Whale Tail Open Pit 2019 Annual Inspection

RE: Amaruq Mine - Whale Tail Open Pit - 2019 Annual Inspection

Amaruq Project - Whale Tail Open Pit - 2019 Annual Inspection

North Wall (5151 Bench)

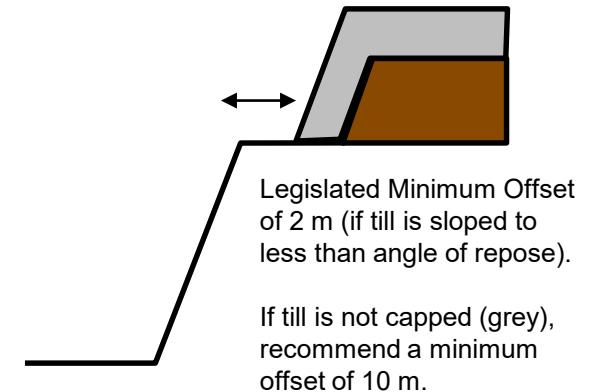
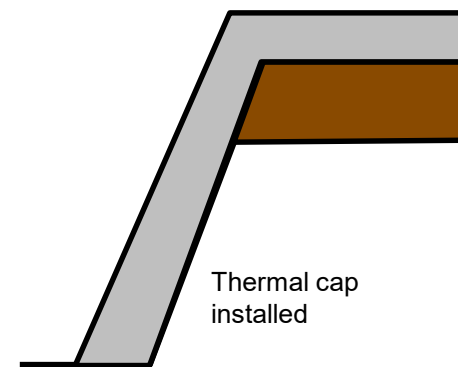
- First bench of the final pit wall in the Greywacke. Design Sector A1.
- There is unconsolidated till at the crest of the bench, and the rock forming the bench itself is broken up. Pre-shear was not used.
- The management of the overburden is discussed on the following slide.
- It is recommended that pre-shear holes be completed for all final walls.

Northeast Wall

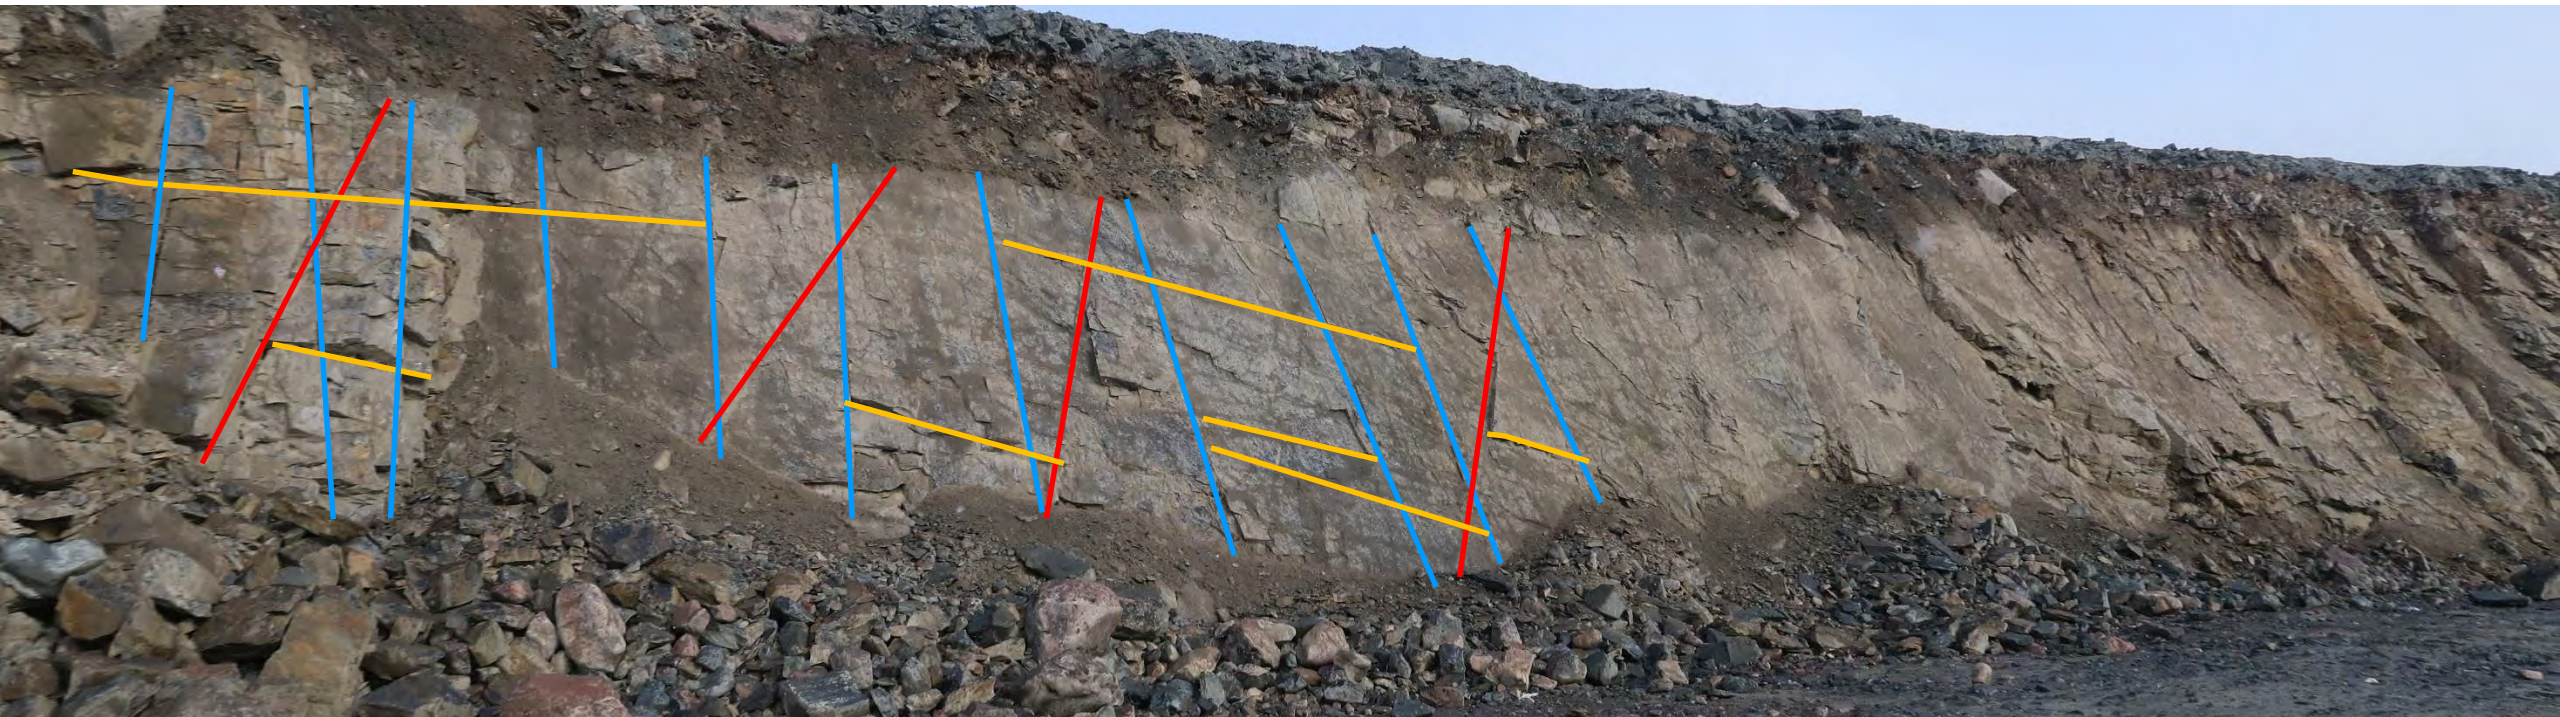
- First bench of the final pit wall in the Greywacke. Design Sector A1.
- The bench performance is controlled by the dip of the foliation, as expected. Bench face angle is approximately 65° , consistent with design.
- Recommend using Maptek Scanner to document bench performance and foliation dip.

East Wall

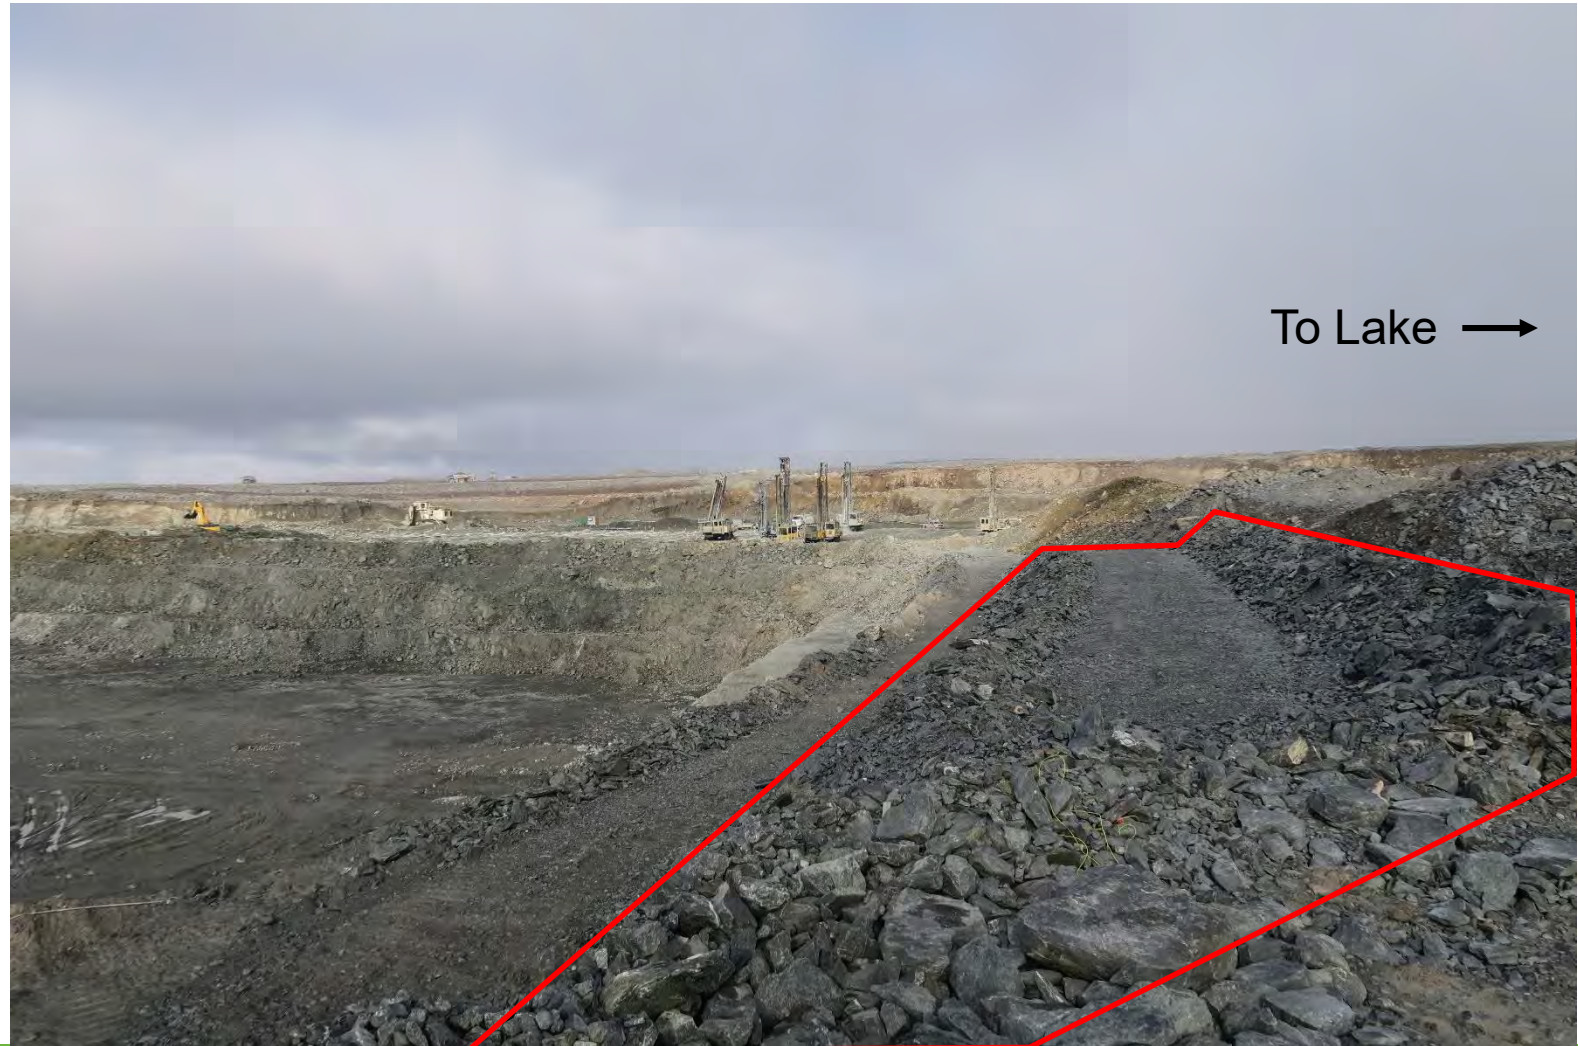
- There has been significant blast damage to these units. No pre-shear was used as it is an interim wall. It is also understood that a higher powder factor was used in these areas. Need to use a different approach for the final walls if the design geometry is to be achieved.

- The Komatiite is highly disturbed. The foliation is prominent and several shears were observed. It is soft enough that teeth marks from the shovel are visible in places. This is more consistent with the expected characteristics of the Komatiite (compared to the Northwest Wall).

- The Chert and/or Iron Formation has performed much more poorly than expected, with numerous small (tens of cm) tabular blocks. This may be due to blast damage, though a few small shears (<5cm) were observed parallel to the foliation. It is important to document how other walls in this unit perform.

Hazard Mapping

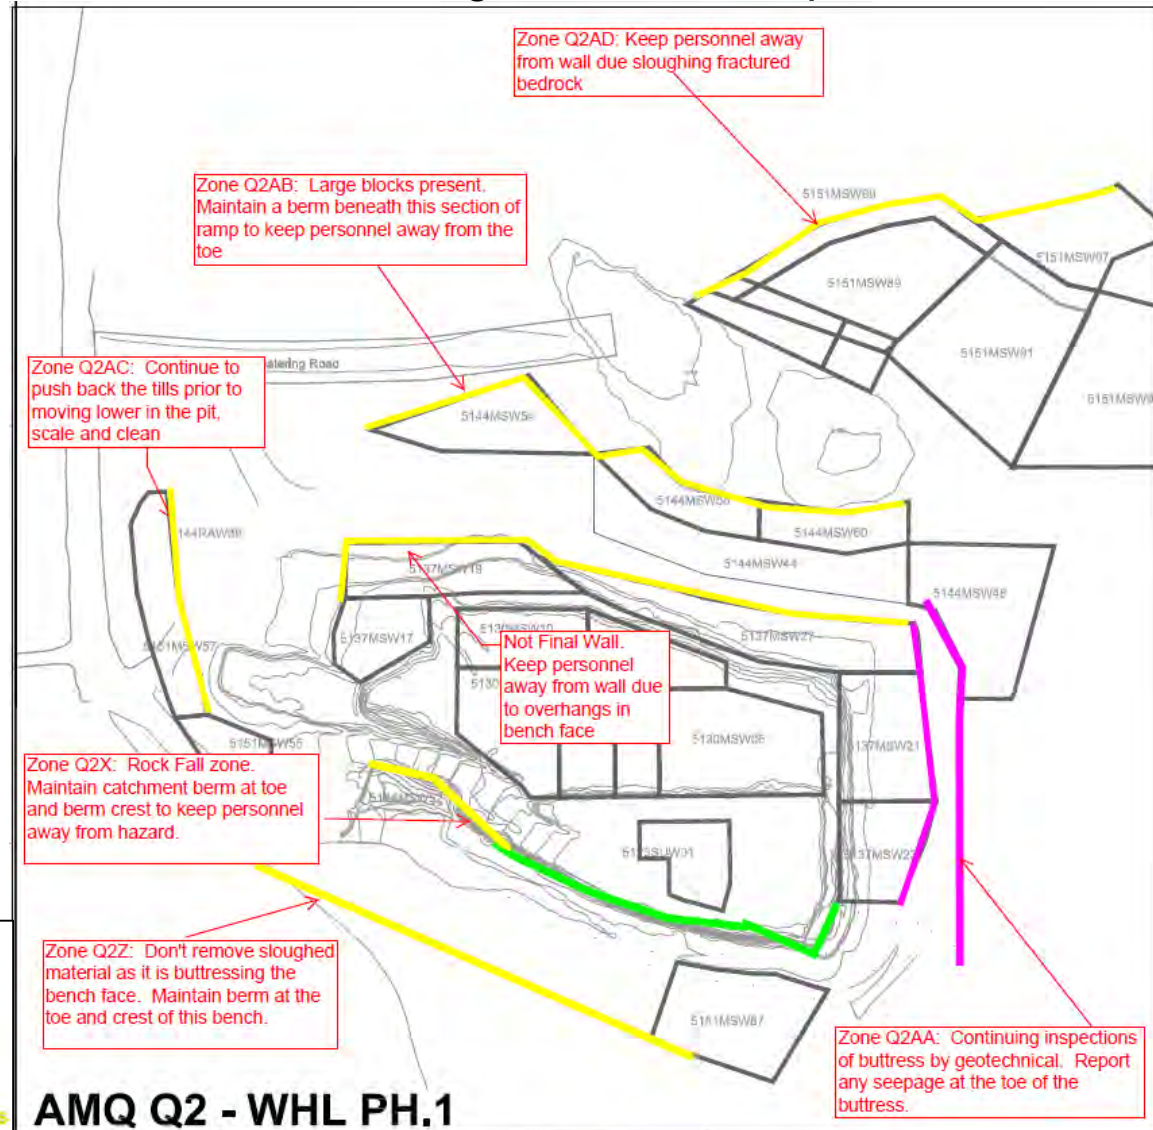
- The hazard ratings used on the hazard maps produced by the geotechnical team were discussed. There is inconsistency between the ratings being applied.
- One possible approach discussed (though others are possible):
 - Low Risk – Personnel to perform self-assessment of work area and accesses, no particular concerns.
 - Medium Risk – Hazard would ideally be removed prior to working near the wall. If the hazard is not removed, precautionary measures (e.g. a spotter, geotechnical inspection, etc.) required.
 - High Risk – Remedial measures (e.g. scaling, berm, etc.) required before work can be completed near the wall.
 - Very High Risk – Exceptional circumstance requiring a specific action plan from the engineering department. Area must be bermed off and access prevented.
- Consider developing a TARP to help with a consistent approach to identifying and rating risks.

Instrumentation

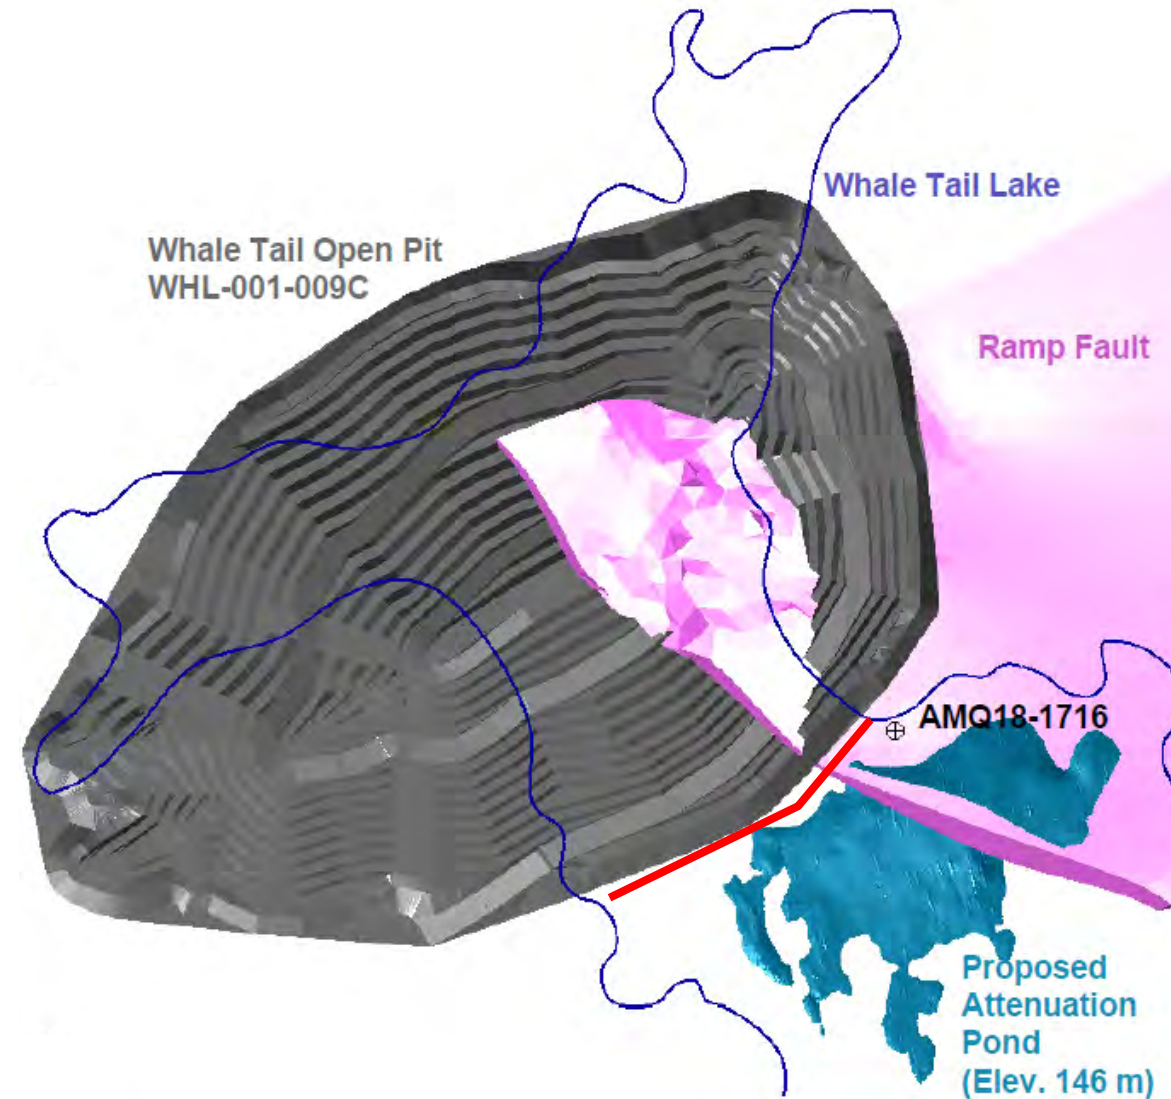
- The area of focus should be the south wall of the open pit below the footprint of Whale Tail Lake. The other walls of the open pit are expected to be within permafrost based on the available thermistor data and the 3D thermal model.

- The following conceptual instrumentation plan was discussed:
 - 3 drillholes along the south wall of the open pit, between the open pit and the attenuation pond (roughly along the red line at right). Approx. 5 piezometers and a thermistor string in each drillhole. The drillholes should extend to the base of the talik zone (approx. 100 m below surface)

- 1 drillhole between the open pit and the Whale Tail Dyke (south of the attenuation pond) with 3 to 5 piezometers. This drillhole is a lower priority than the others.

Fall of Ground

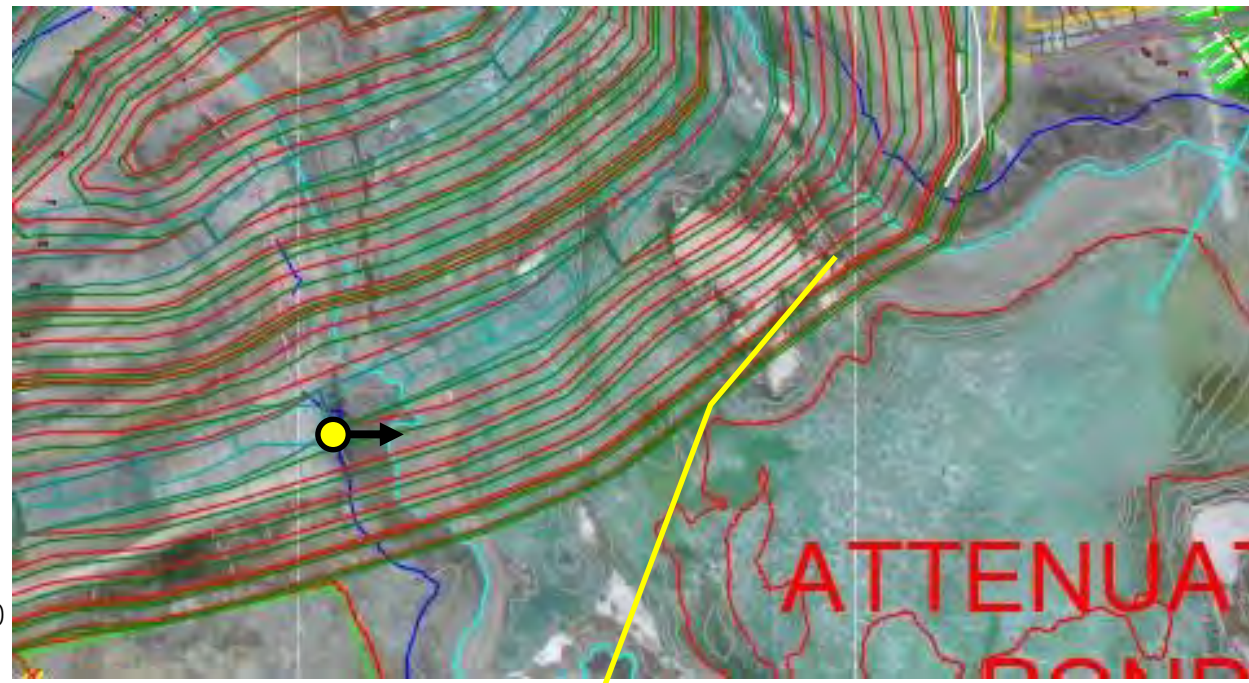
- The Fall of Ground that occurred on the southwest wall of the open pit on June 9, 2019 was reviewed.
- A wedge of approx. 385 tonnes failed along the sub-horizontal Joint Set C ($38^\circ / 258^\circ$, dip / dip direction). The orientation of the second release plane is not clear. It may be the foliation, which is subvertical and dips into the wall in this area.
- The area as since been blasted.
- As a note, the Rock Fall Log is a good tool for documenting slope performance and provides an opportunity to learn from previous failures. It would be helpful to document the Failure Mode (e.g. planar, wedge, rockfall, circular failure, etc.) and, for kinematic failures, the Joint Sets involved.
